## EXTERIOR WALL CONDITION ASSESSMENT REPORT

May 12, 2024

**Regarding:** Exterior Wall Condition Assessment

2 Detail - parapet @ curtain wall  
1'-0\"/>

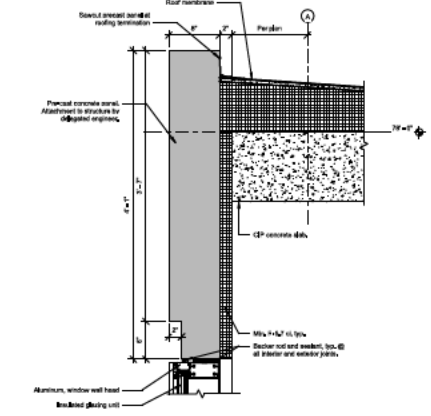
Detail 2 on Sheet A11.5 requires a metal framed wall to be installed above the concrete roof deck, behind the curtain wall, and a wood nailer to be installed above the metal framed wall and curtain wall. A continuous metal clip is required to be installed above the curtain wall to receive the metal panels, and is to be stripped in with the roof membrane. According to notes on the

as-built drawings, RFI089 regarding Roof Blocking Attachment and RFI249 regarding Roof Parapet CW (curtainwall) Detail Confirmation were submitted, but these RFI's were not provided for review at the time of report preparation.

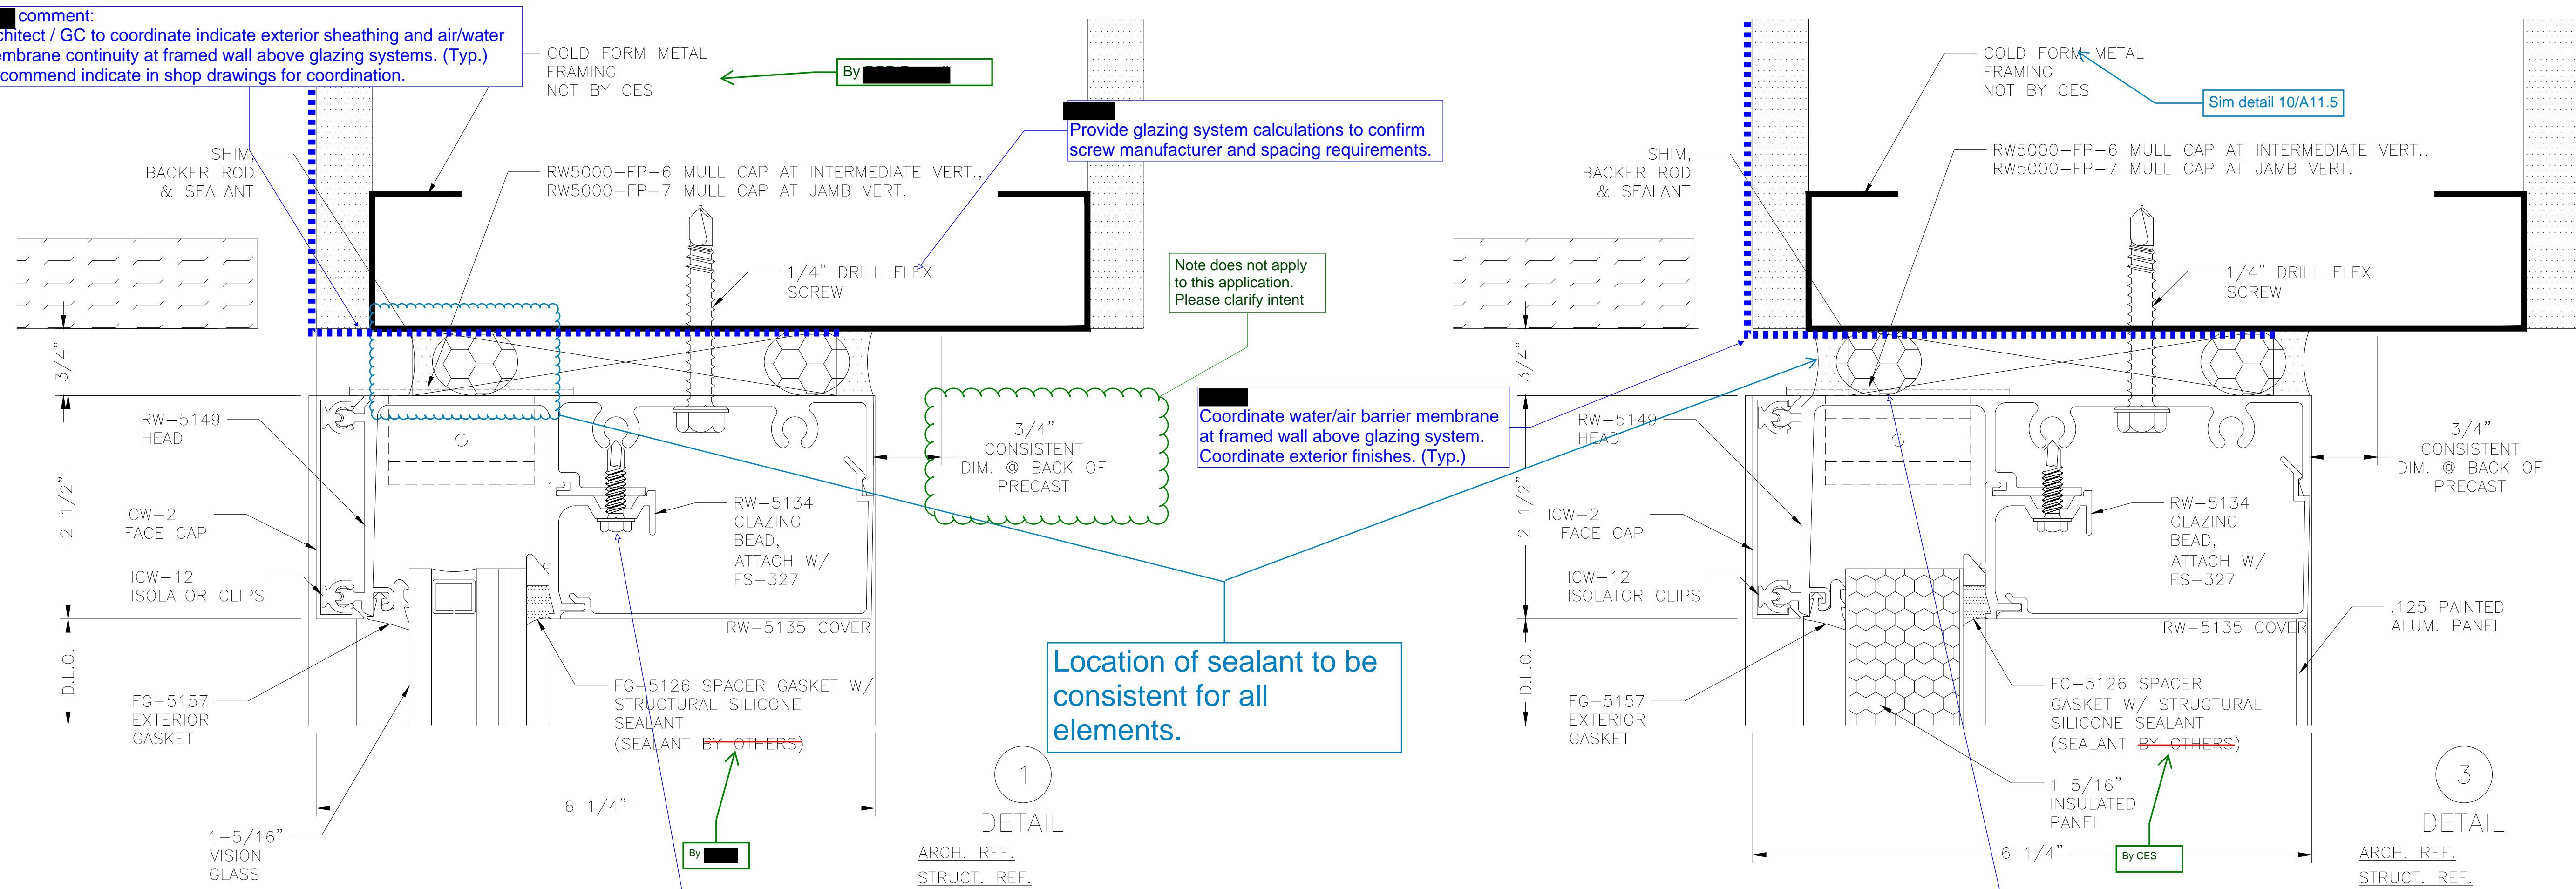
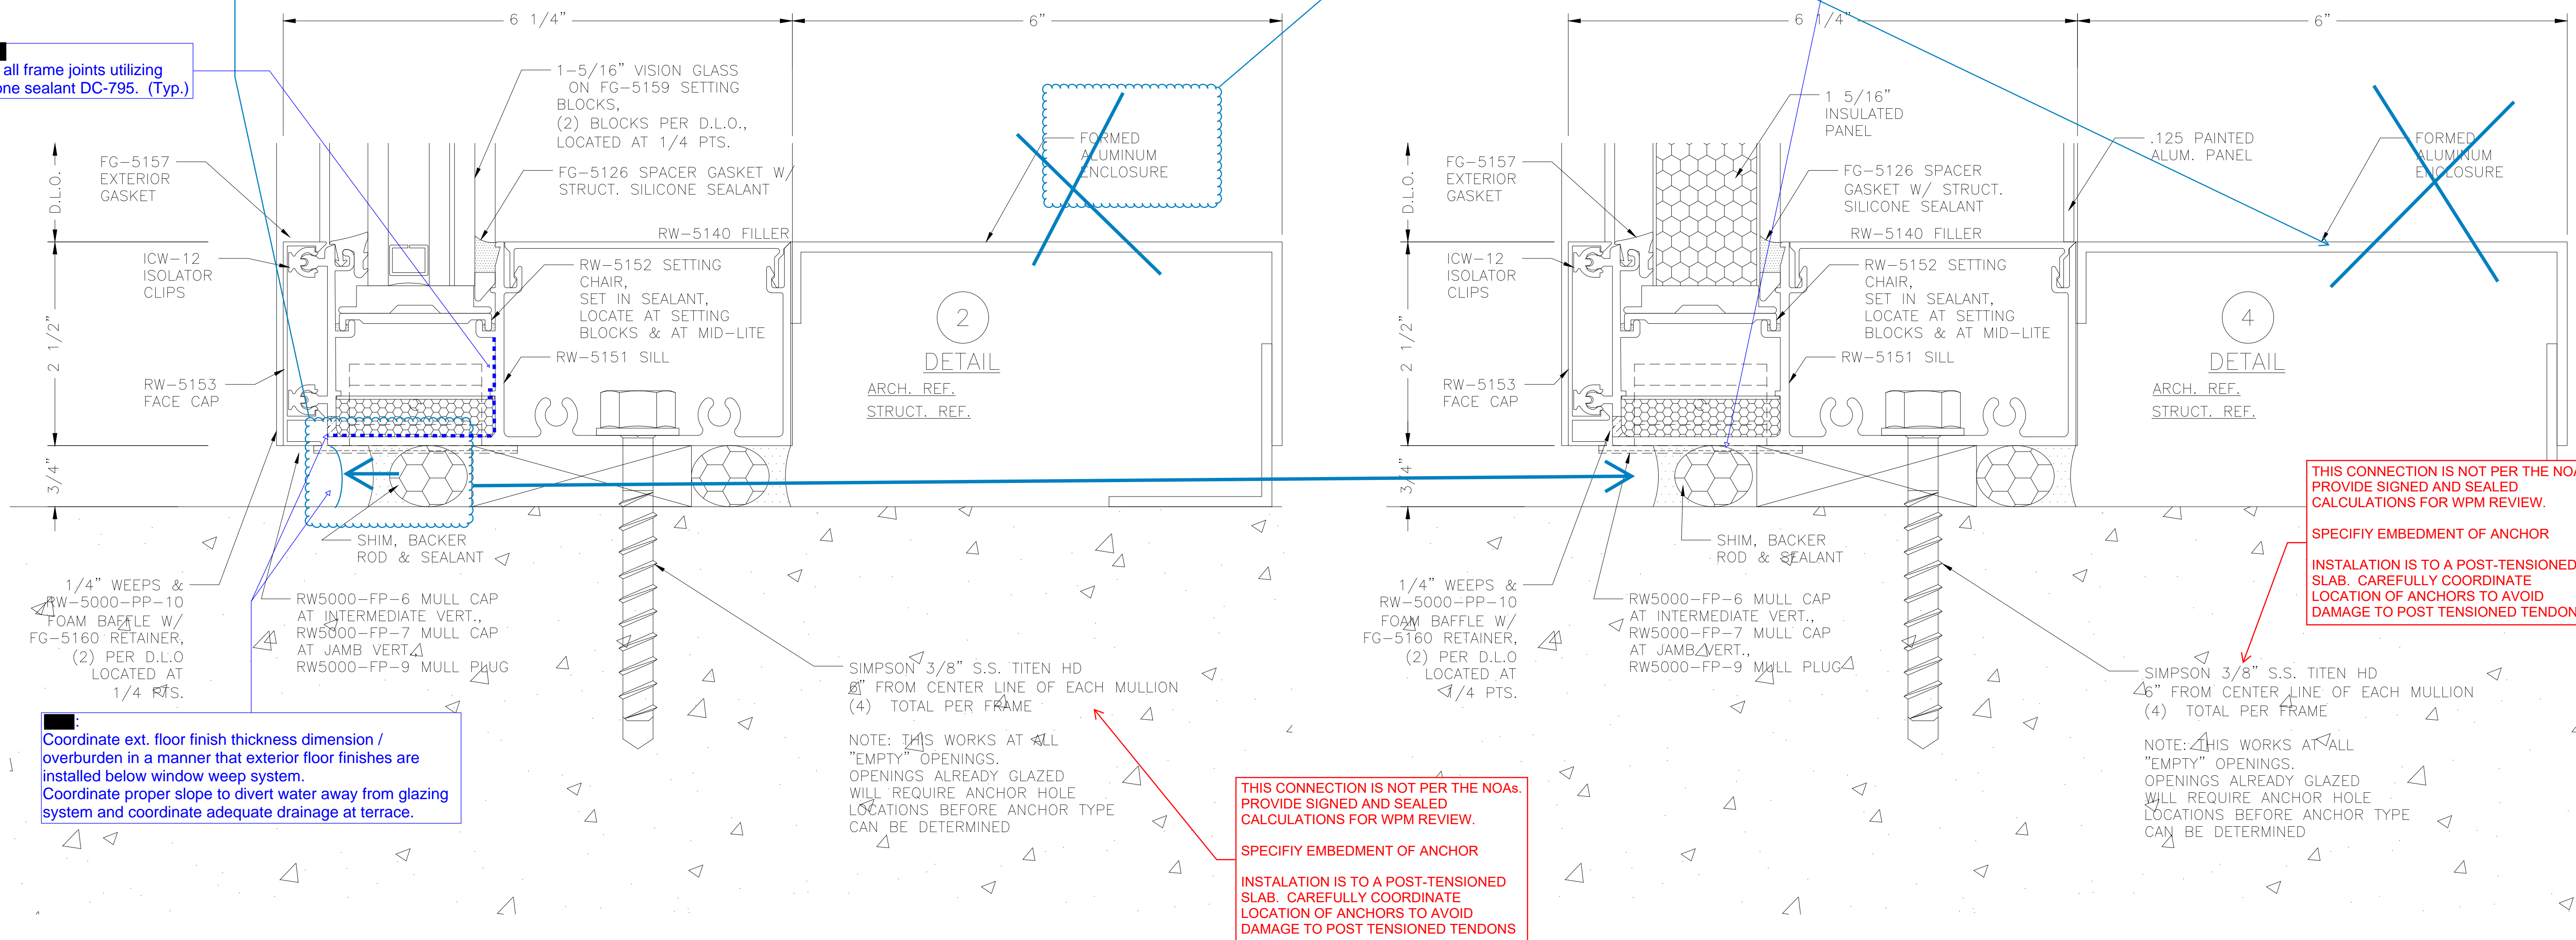
comment:  
Architect / GC to coordinate indicate exterior sheathing and air/water membrane continuity at framed wall above glazing systems. (Typ.)  
Recommend indicate in shop drawings for coordination.

██████ to confirm if location of sealant as noted does not work with their system, typ.

Seal all frame joints utilizing  
silicone sealant DC-795. (Typ.)
